Swedish Radiation Safety Authority

Technical Note

2014:43

Workshop on general
corrosion of copper

Figure 1. Safety features for compacted bentonite buffer as a function of saturated density from Posiva, 2009, based on the Finnish version of SKB's KBS-3 concept.

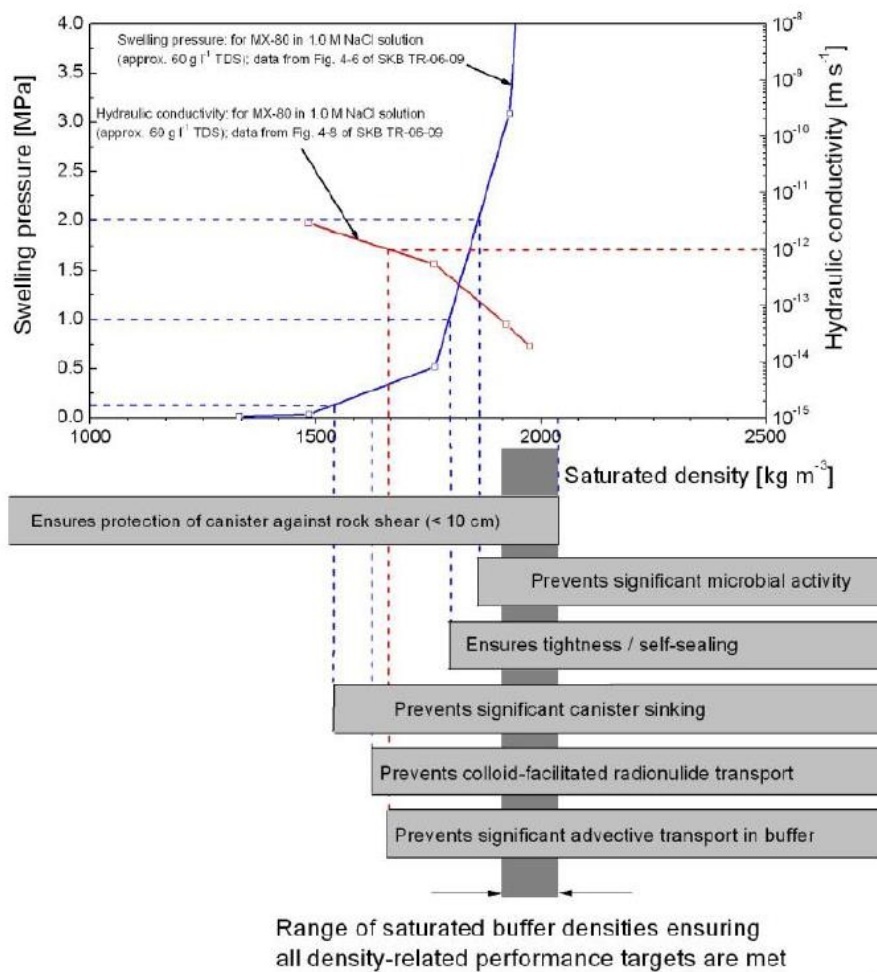
For the assumptions and data applied for the intact buffer case, SKB’s analyses showing canisters failures only occurring at extremely long time periods ($>>10^5$ years) seems defensible. This sets the focus on situations in which buffer may erode or be mis-emplaced, leading to lower buffer density that may compromise or degrade safety features of the buffer. With decreasing buffer density, impacts on buffer performance could include loss of buffer ‘tightness’ against rock and canister, onset of microbial activity within the lower-density buffer, and eventually onset of advective flow conditions (Figure 1).

Both the rate of buffer erosion and the rheological response of an eroding buffer over extended time periods (> a few years) are uncertain because of obvious practical limitations to the duration of tests. SKB has selected a simplified force-balance model with a higher rate of buffer erosion rather than the alternative, more complex phenomenological model also developed for SKB. Several participants suggested that comparison and possible linkage between these two SKB models could aid in confirmation and confidence in understanding long-term buffer erosion.

A further concern is the uncertainty in buffer response to sustained erosion. As SKB notes (TR-11-01, page 600, 2011), “A smaller [canister contact-area experiencing advective flow] yields a higher corrosion rate since all incoming sulphide is assumed to react with the exposed canister surface.” The hemi-spherical assumptions for buffer erosion adopted in SR-Site are rationalized by SKB, but other geometries for advective flow might be envisioned. In particular, the possible occurrence of extremely narrow (hence, small surface area contact with a canister) channels or ‘tubes’ through or across the buffer has been raised (see Section 3 of this report).

Figure 3. Histogram representation of predicted fracture flow rates for different conceptual DFN models of the Forsmark site (source: Geier, 2011, SSM report 20011:13)

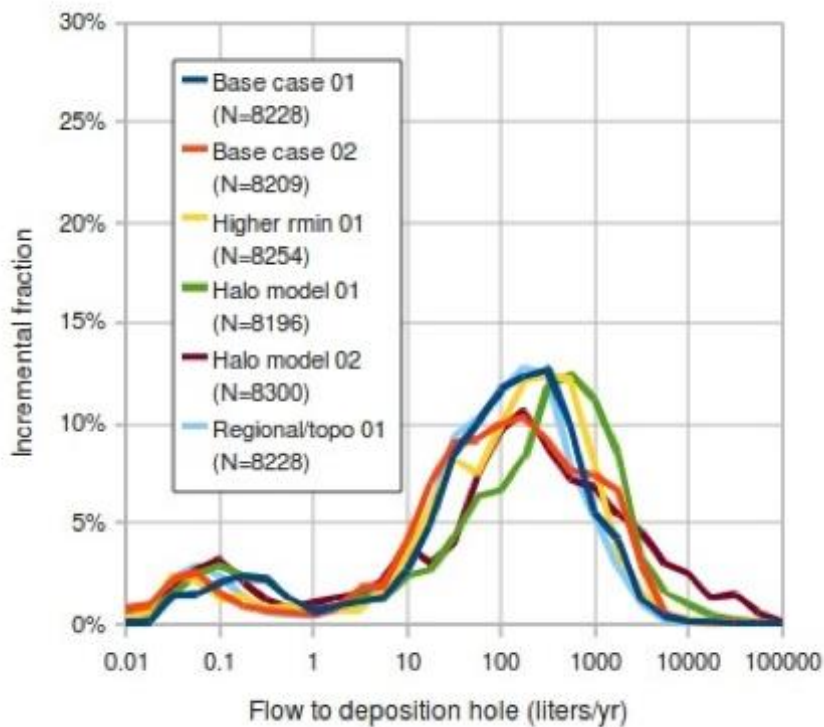
As an example of an alternative DFN model, so-called 'halo' models have been evaluated in which there are more hydrologically 'tight' deposition holes, but higher (by perhaps as much as 1 to 2 orders of magnitude) flow for the smaller percentage of deposition holes that do see flow. Figure 3 compares several different conceptual DFN models with respect to the fraction of deposition holes vs. the calculated flow into that deposition hole. Other alternative DFN conceptual models, such as sparse channel network (Black et al, 2007), would be expected to yield significantly higher flow into a fraction of deposition holes if applied to the Forsmark site. The other concern regarding this sparse-channel conceptual model is whether narrow channels (rather than planar fractures) intersecting a deposition hole would lead to a phenomenologically different model for chemical erosion of buffer.

A final concern that was raised was SKB’s assumed favourable implementation of criteria for deposition hole rejection (SKB, TR-11-01, page 578). Application of such criteria, by definition, truncates deposition holes that might have both higher groundwater flow rates and potential for faster buffer erosion. It was recommended that a separate study or workshop be devoted to the confidence in SKB’s ability to develop and apply such criteria for deposition hole rejection.

Figure 4. Selected set of measured sulphide concentrations for the Forsmark site at depths below 50 meters. Figure 10-41, SKB, 2011.

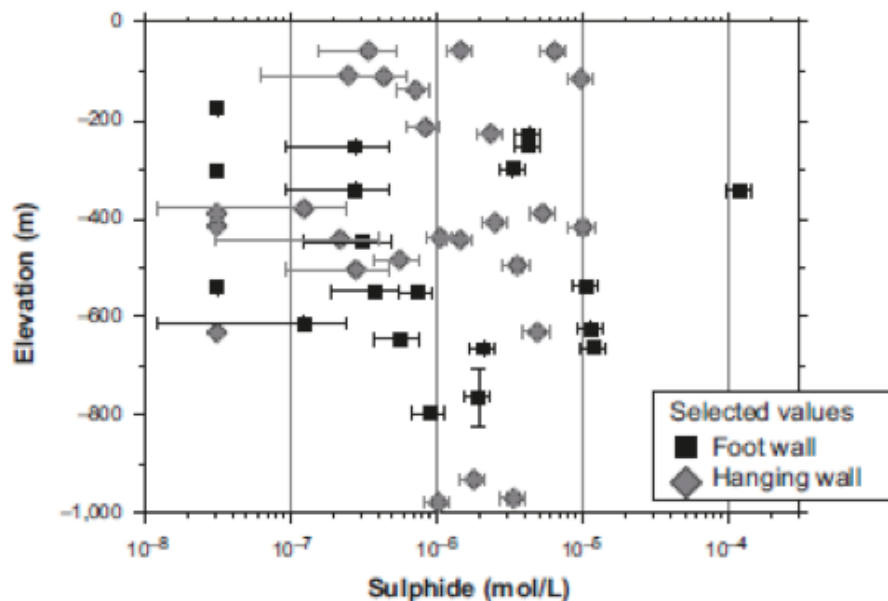
The assumption that a maximum $[\text{HS}^-]$ will be set by FeS precipitation was discussed. The preponderance of $[\text{HS}^-]$ measurements are consistent with the predicted FeS solubility-limited concentration. The few elevated $[\text{HS}^-]$ measurements could arise from the local absence of Fe^{2+} in association with SRB activity. Further explanation and evidence from SKB might help to understand and interpret the few anomalously high measurements of $[\text{HS}^-]$. The availability of energy and nutrient sources could act as constraints on the viability of SRB in the rock and buffer.

The role of microbial viability in the SR-Site assessment of maximum $[\text{HS}^-]$ is unclear. SKB's focus on the consequence of decreasing buffer density from erosion to enable advective flow ought to also consider the potential onset of microbial viability in eroded buffer, which would likely arise prior to the onset of advection (Figure 1). There may be regions with limited availability of dissolved Fe^{2+} , so that the FeS solubility-limit would not play a significant role. Therefore, in such a case with lowered buffer density enabling microbial activity, the maximum reduced sulphide at the canister surface might be set by the flux of dissolved sulphate to that surface, which could be higher than the flux of dissolved sulphide. This might be a variant or residual case for which SKB could present further evidence and analyses.
